## FIELD CHANGE ORDER

TU77A

0007

THIS REVISED FCO SUPERSEDES THE ORIGINAL RELEASE OF 15 MAY 1981. IT PROVIDES THE FOLLOWING CORRECTIONS: ON PAGE 11, REWORK STEPS 39 AND 40 WERE ADDED.

FIGURE 1

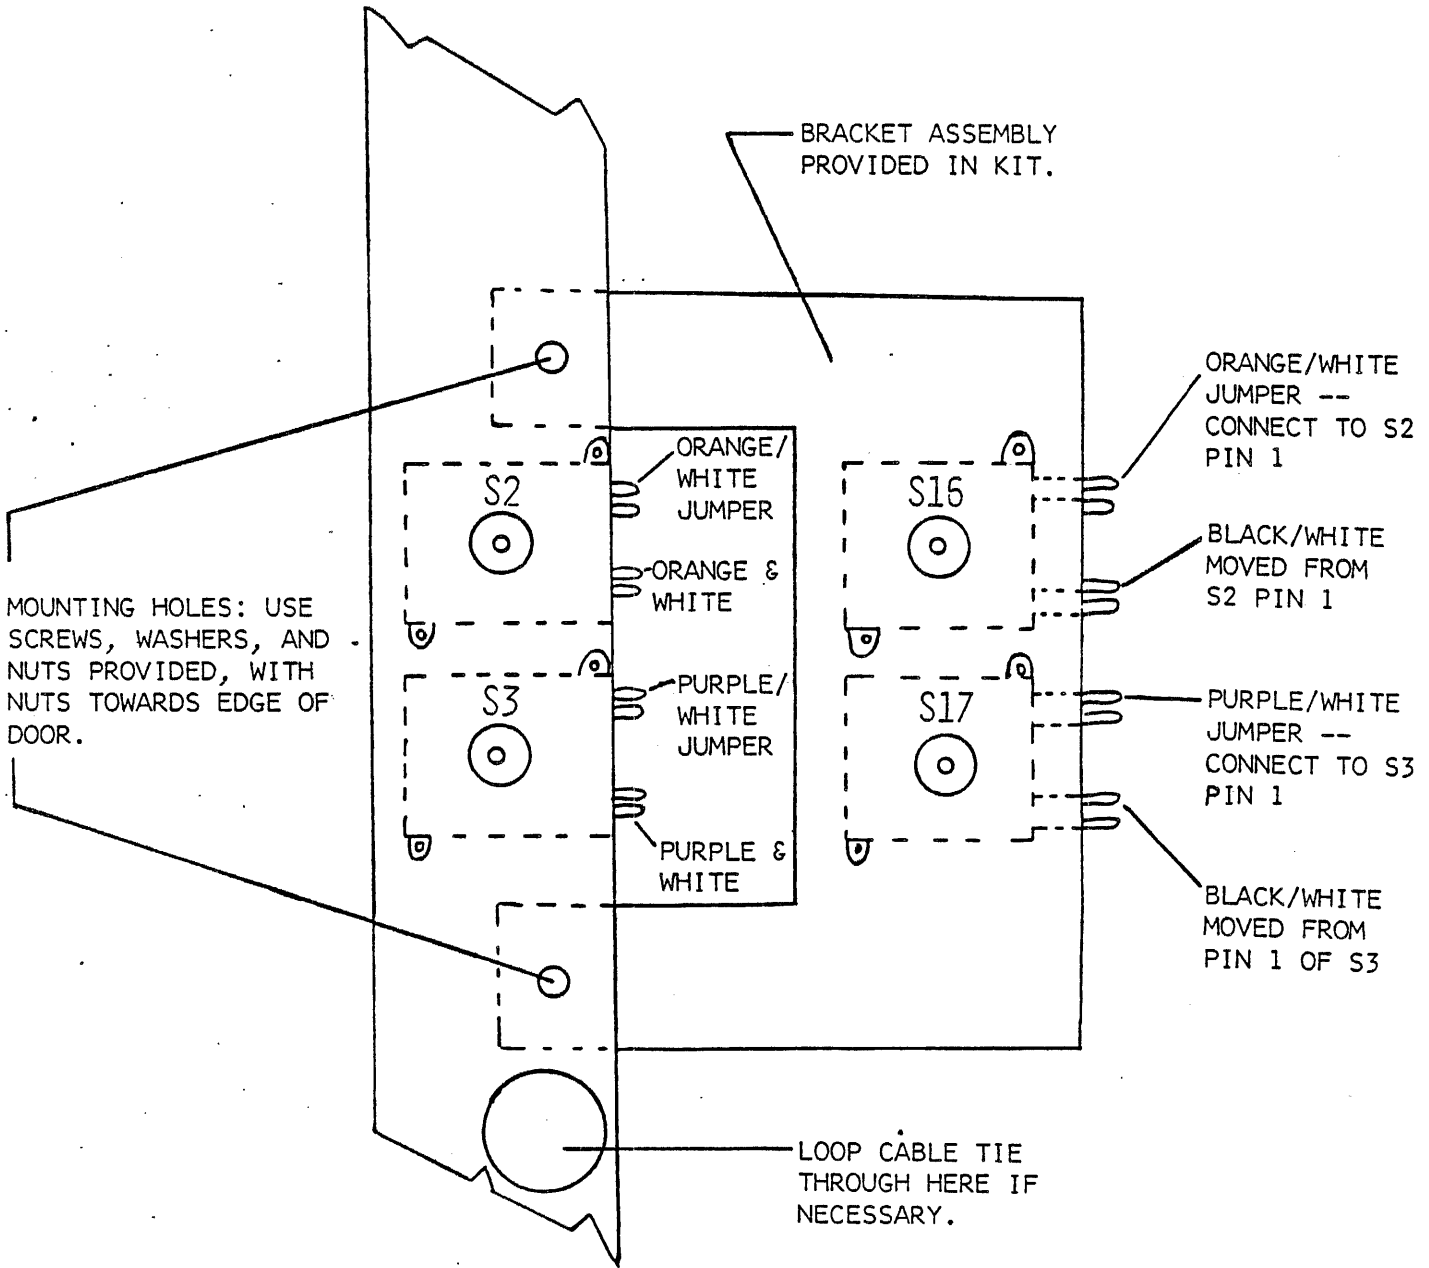
- 1- POWER DOWN DRIVE.
- 2- OPEN MAIN DECKPLATE AND LOCK IN PLACE.
- 3- REMOVE AND DISCARD SWITCHES S2 AND S3. INSTALL SWITCHES, VENDOR PART NUMBER 506-0023, IN S2 AND S3 LOCATIONS. (FIGURE 1)
- 4- MOUNT PRE-ASSEMBLED SWITCH ASSEMBLY ON INBOARD SIDE OF PRESENT SWITCH MOUNTING BRACKET IN HOLES JUST ABOVE AND BELOW S2 AND S3. (FIGURE 1)
- 5- REMOVE HOSE FROM S2 (DOOR EDGE SIDE). INSTALL HOSE ON CENTER OF PLASTIC T COMING FROM NEW SWITCH ASSEMBLY S16.
- 6- CONNECT OTHER BRANCH FROM T ON S16 TO S2.
- 7- REMOVE HOSE FROM S3 (DOOR EDGE SIDE). INSTALL HOSE ON CENTER OF PLASTIC Y COMING FROM NEW SWITCH ASSEMBLY S17.
- 8- CONNECT OTHER BRANCH OF Y FROM S13 TO S3. USE CABLE TIE, IF NECESSARY, TO DRESS TUBE GOING TO LOOP PORT. RUN TIE THROUGH HOLE. (FIGURE 1)

FIGURE 2

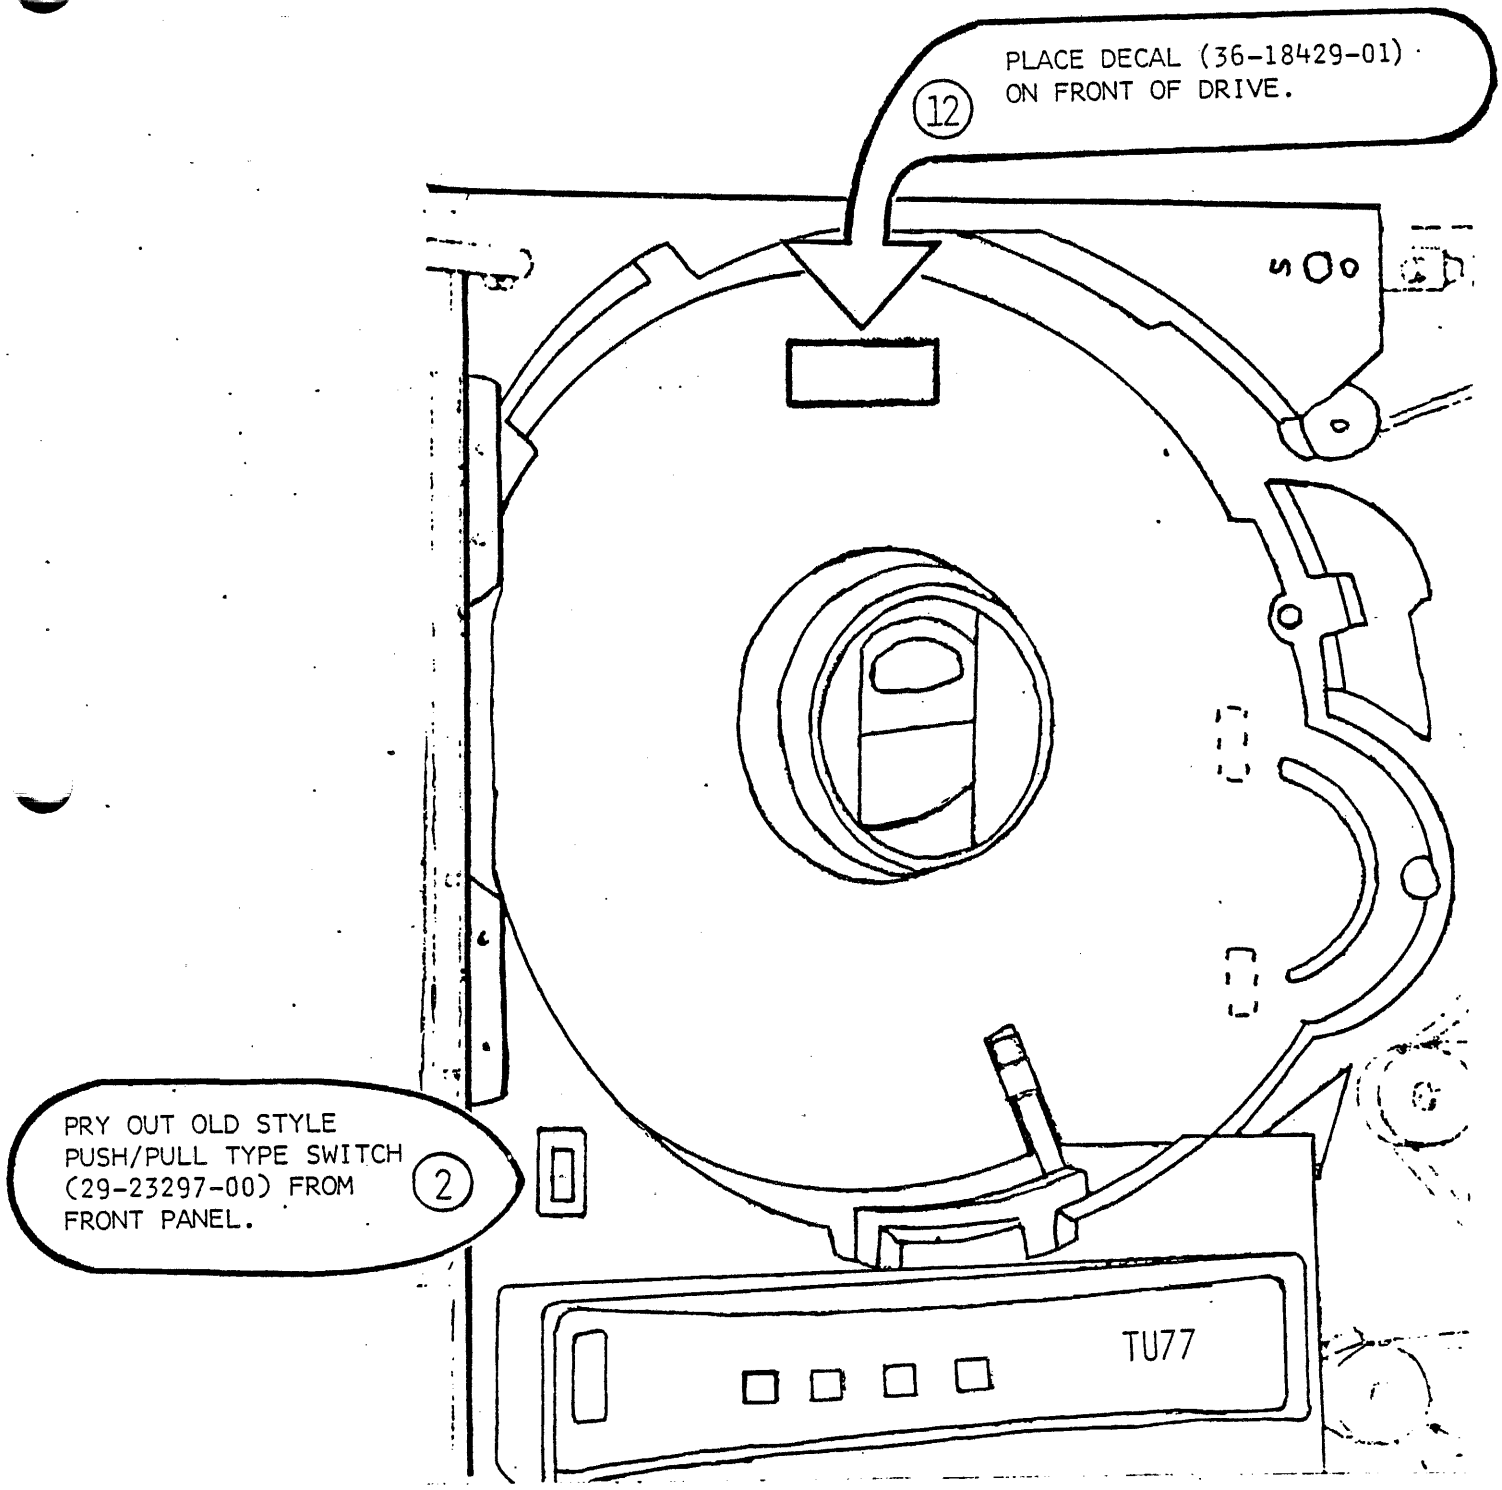
- 1- POWER DOWN DRIVE.
- 2- PRY OUT OLD STYLE PUSH/PULL TYPE SWITCH (29-23297-00) FROM FRONT PANEL. (FIGURE 2) (IT MAY BE NECESSARY TO REMOVE THE COMPLETE DOOR ASSEMBLY TO REPLACE THE SWITCH.)
- 3- REMOVE TWO SPADE CONNECTORS FROM OLD SWITCH, ENSURING WIRES DO NOT SLIP INTO HOLE.
- 4- INSTALL SPADE CONNECTORS ON NEW SWITCH (12-14073-01).
- 5- CAREFULLY INSTALL NEW SWITCH IN OLD SWITCH LOCATION. BE CAREFUL NOT TO CRIMP WIRES.
- 6- POWER UP DRIVE.
- 7- MOUNT A FULL 10.5 INCH, 2400 FT. REEL ON DRIVE WITHOUT CARTRIDGE.

PRY OUT OLD STYLE PUSH/PULL TYPE SWITCH (29-23297-00) FROM FRONT PANEL.

- 8- MOVE NEW SWITCH TO "MAN" (MANUAL) POSITION.
- 9- CLOSE DOOR AND DEPRESS LOAD/REW SWITCH. REEL SHOULD NOT BACKWRAP.
- 10- UNLOAD TAPE AFTER REACHING BOT.
- 11- MOVE NEW SWITCH TO AUTO POSITION, CLOSE DOOR AND DEPRESS LOAD/REW SWITCH. REEL SHOULD BACKWRAP BEFORE LOADING.
- 12- PLACE DECAL (36-18429-01) ON FRONT OF DRIVE. (FIGURE 2)
- 13- RECORD INSTALLATION IN SITE LOG AND COMPLETE LARS REPORT.

FIG.2 (New style)

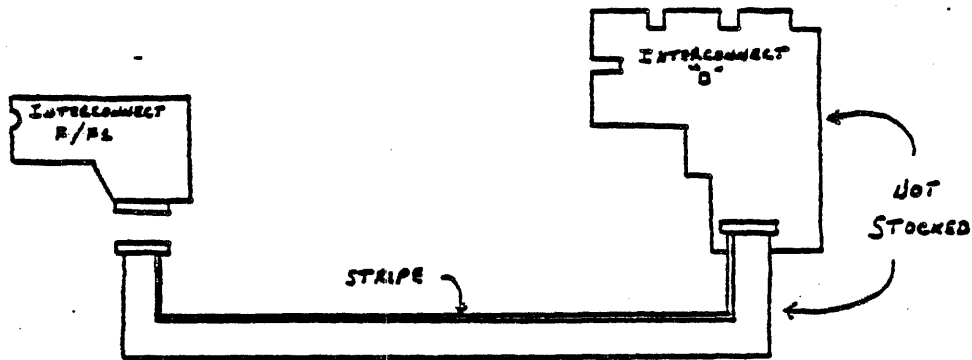
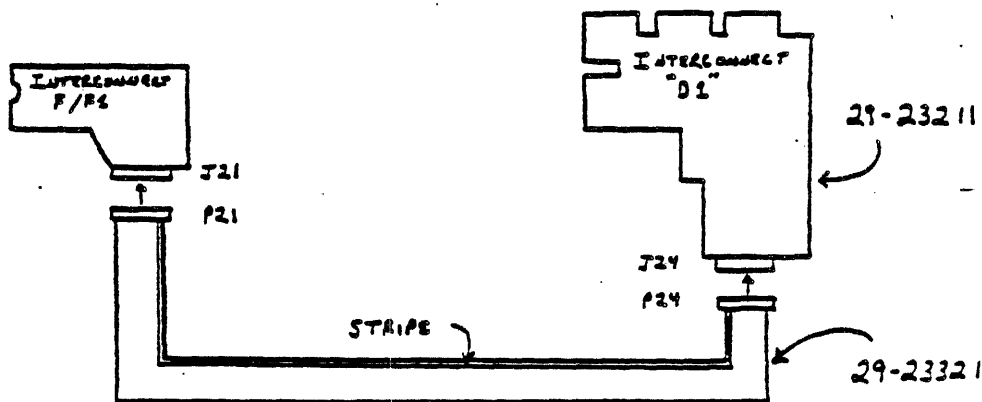
Early TU77 transports shipped with the Interconnect "D" backplane. This backplane includes a cable which is soldered to the etch and runs up to the interconnect F/F1 PCBA on the base assembly (see Fig. 1). Later models (approximate serial #5250 and up) use the Interconnect "D1" backplane which has a detachable cable (See Fig. 2). Logistics will not stock the Interconnect "D" assembly but rather will stock the Interconnect "D1" (29-23211) and the cable (29-23321) separately.

Consequently, if an Interconnect "D" backplane/cable assembly should fail in the field, it must be replaced with the newer style "D1" and the cable assembly must be ordered as a separate line item.

FIG. I

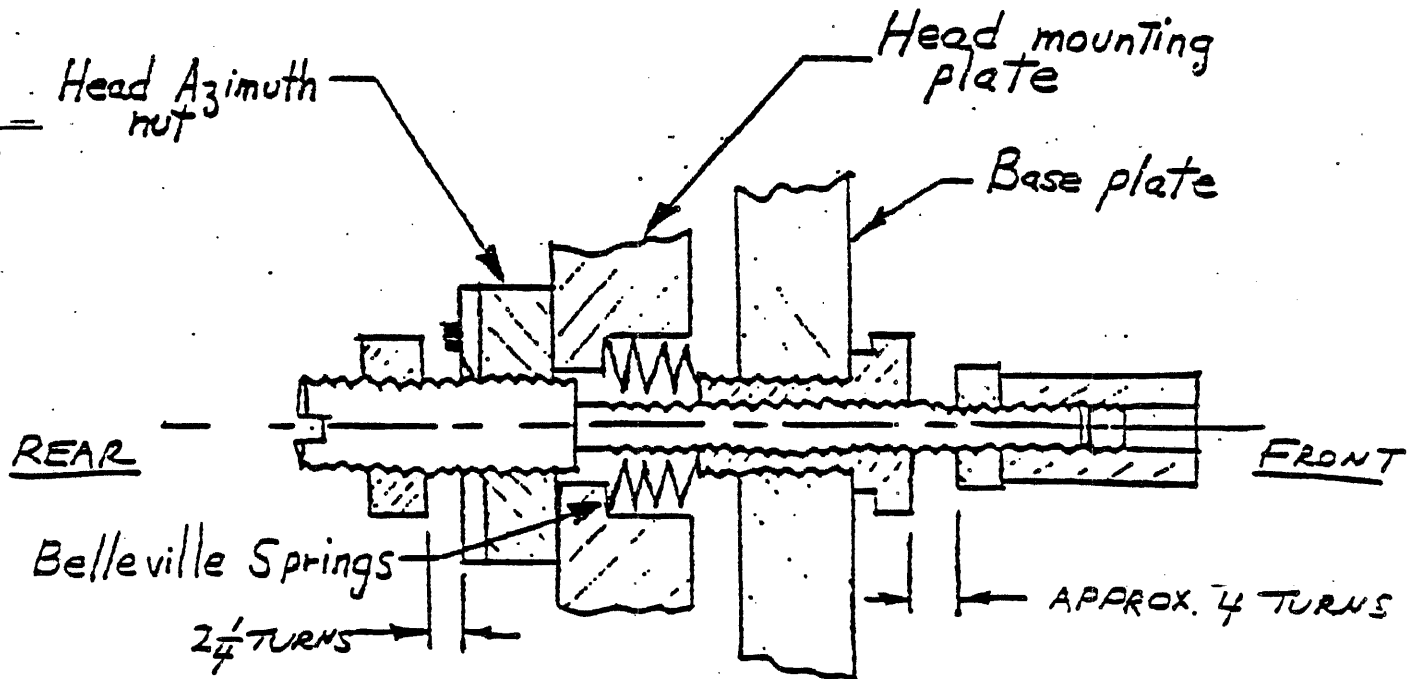
REFER TO FIGURE 1. THE ADJUSTING SCREW NOW PROTRUDES THROUGH THE REAR OF THE HEAD MOUNTING PLATE AND THE HEAD AZIMUTH NUT. THE SCREW IS SECURED IN THE AZIMUTH NUT WITH LOCTITE.

BEFORE THE ADJUSTING SCREW CAN BE TURNED FROM THE FRONT OF THE DRIVE, AS PER THE ADJUSTMENT PROCEDURE, THE LOCTITE SHOULD BE BROKEN BY INSERTING A STRAIGHT BLADE SCREWDRIVER INTO THE REAR OF THE ADJUSTING SCREW AND TWISTING. THE AZIMUTH MAY NOW BE ADJUSTED FROM EITHER THE FRONT OR REAR OF THE DRIVE AND WILL HOLD THE ADJUSTMENT WITHOUT ADDING ANY MORE LOCTITE.

Figure 1 Interconnect F1 PCBA Adjustments and Test Points

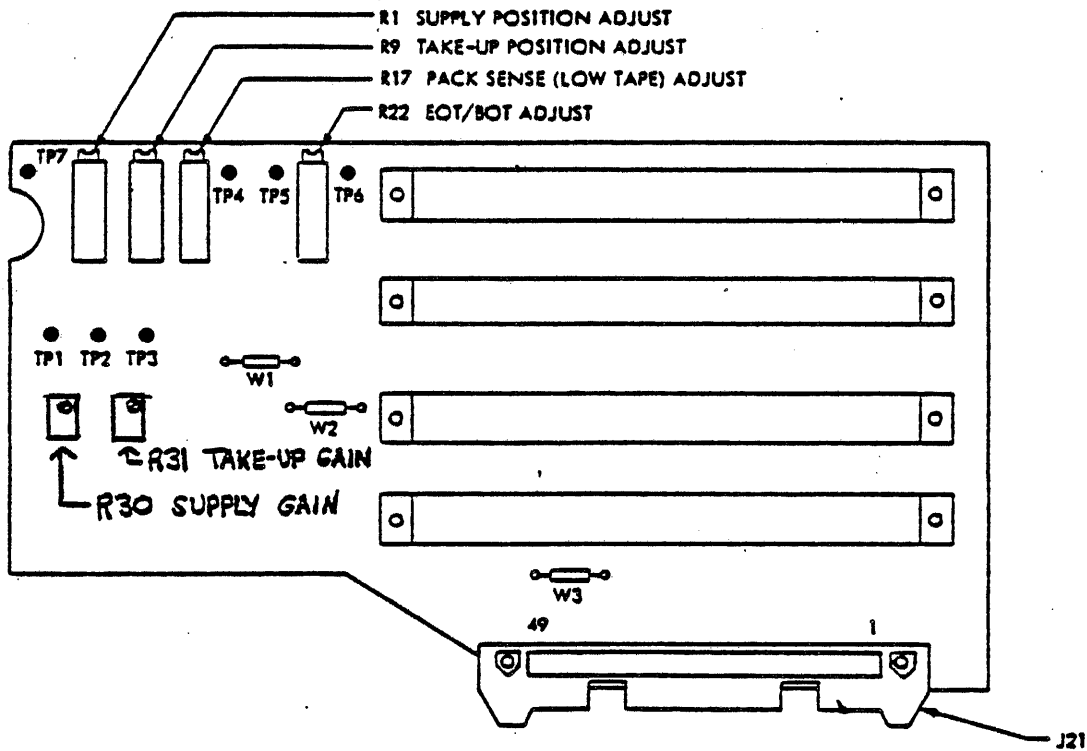
IN ORDER TO REDUCE REEL SERVO CIRCUIT POWER CONSUMPTION AND HEAT DISSIPATION, TWO SERVO GAIN POTS HAVE BEEN ADDED TO THE INTERCONNECT F1 PCBA. THE ACCOMPANYING DIAGRAMS SHOW THE LOCATION OF THE POTS ON THE F1 PCBA AND IN THE CIRCUIT SCHEMATICS. FOLLOWING IS:
